## REVISED RESPONSE TO REQUEST FOR ADDITIONAL INFORMATION

### APR1400 Design Certification

Docket No. 52-046

RAI No.: 481-8546  
Review Section: 16 – Technical Specifications  
Application Section: 16.3.4, 16.3.5, 16.3.6, 16.3.7, 16.3.9  
Date of RAI Issue: 09/04/2015

Figure 1 RCS Elevation View

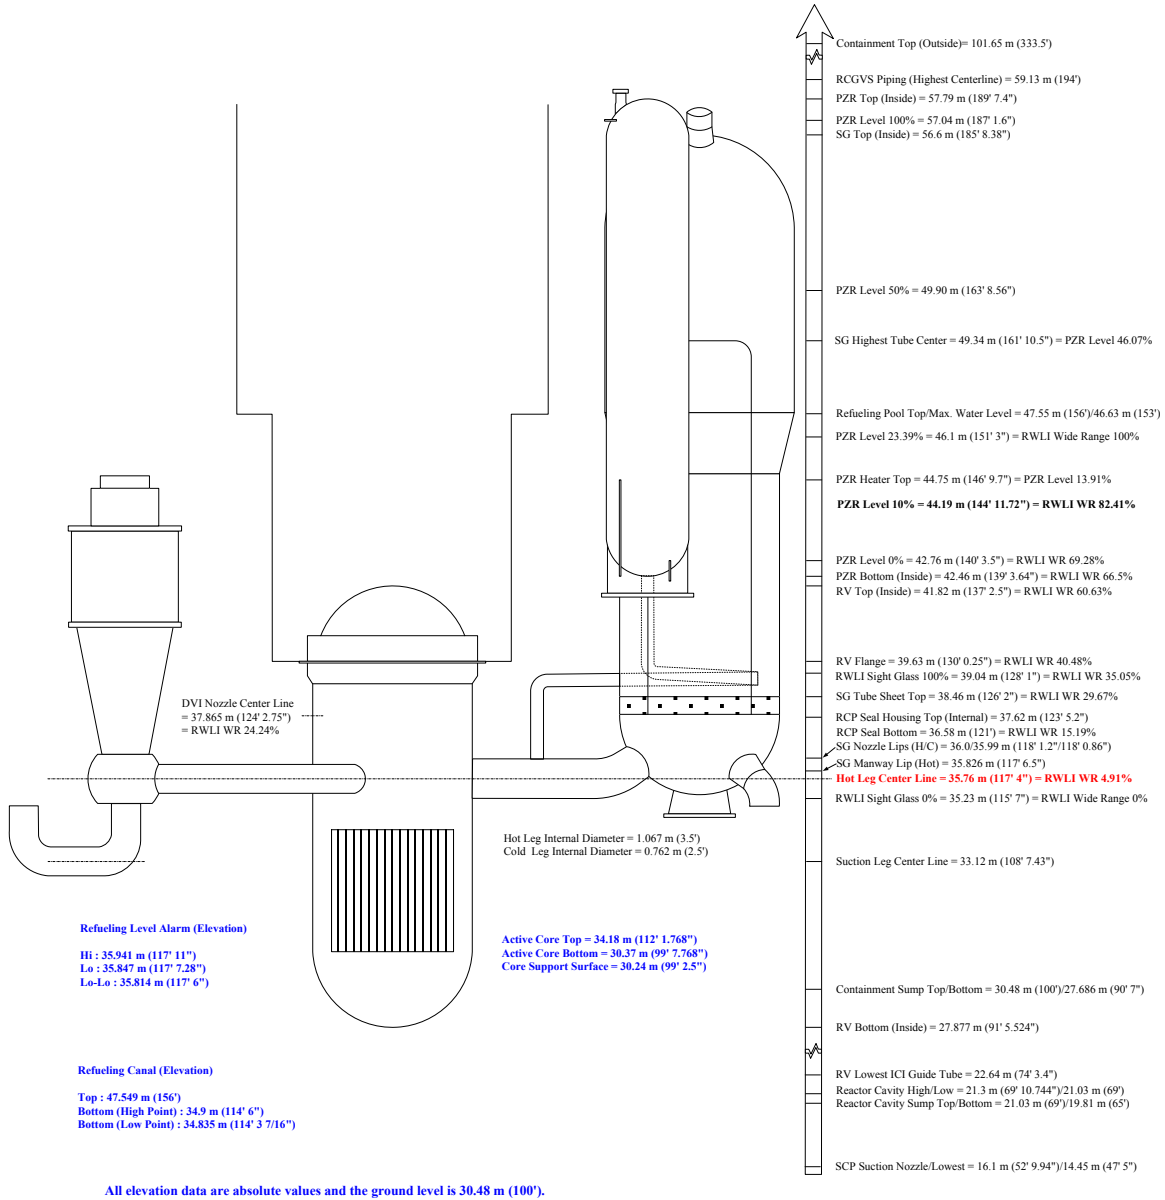
- 2.K A description on an entry condition into the loops filled or the loops not filled will be added in Applicability sections of B3.4.7 and B3.4.8 as follows;

The MODE 5 with RCS loops filled condition is when the steam generators (SGs) can be used for the core decay heat removal. This loops filled condition can be maintained while draining the RCS provided the reactor coolant level is maintained above 134 ft, since below this level, containment atmospheric pressure can no longer completely support the column of water remaining in the SG tubes above the reactor coolant level. At reactor coolant level below 134 ft, water vapor voids begin forming in the horizontal portions of SG tubes, beginning with the highest tubes. The number of affected tubes increases as RCS level decreases until all tubes contain water vapor voids. SG tubes containing voids of water vapor, at the saturation temperature corresponding to vapor pressure of the coolant in the tubes, block coolant flow and secondary heat transfer. When reactor coolant level has decreased to 119 ft 1 in (just above the highest point of the hot leg), air can begin entering the hot leg through the surge line connection and displace the coolant remaining in the SG tubes. This results in the SG tubes being filled with non-condensable gases. The condition in MODE 5 with RCS water level within the top half of the hot legs is called mid-loop operation.

Restoring the unit to the MODE 5 with RCS loops filled condition requires raising RCS level above 134 ft during a draining operation, provided no air was introduced into the

SG tubes. Restoring the unit to the MODE 5 with RCS loops filled condition following mid-loop operation requires closing the pressurizer manway, filling the pressurizer, and dynamically venting non-condensable gases from the SG tubes and reactor vessel closure head using the RCGVS and the reactor coolant pumps.

A forced circulation by the reactor coolant pumps (RCPs) in the MODE 5 with loops not filled condition is possible when the static head of the water from pressurizer water level establishes an RCS pressure high enough to run an RCP.
